# Franklin Township

### MEMORANDUM

Re: Somerset Group Hospitality, LLC – Parking Variance (ZBA-20-000011)  
60 Cottontail Lane (Block 530.04; Lot 1.01)

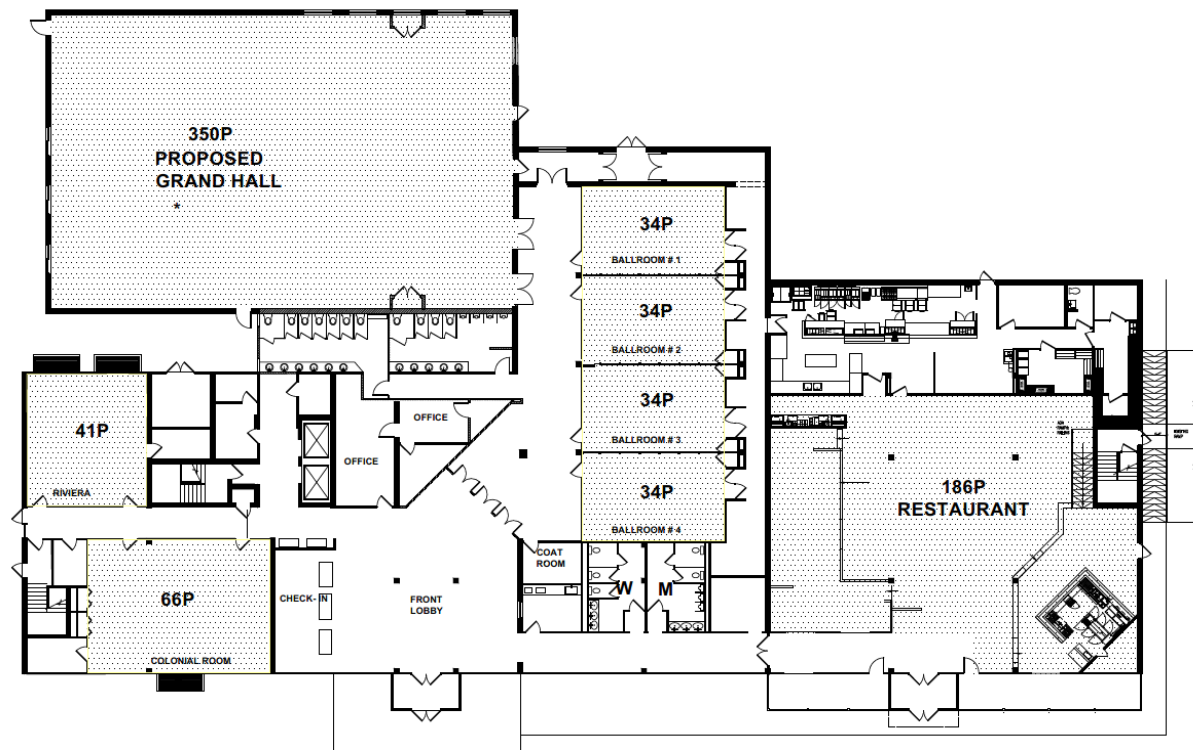
The existing floor plan, with current occupancy levels of the banquet rooms and restaurant (totaling 570 persons), is shown below:

1. The applicant needs to provide quantitative proof in support of the claim that there is "more than adequate parking at present." Further, it is noted that the above statement indicates that there is "more than adequate parking *at present*" (emphasis added). The applicant will obviously need to demonstrate that there will be adequate parking with the 200+ person increase in occupancy proposed on the site.
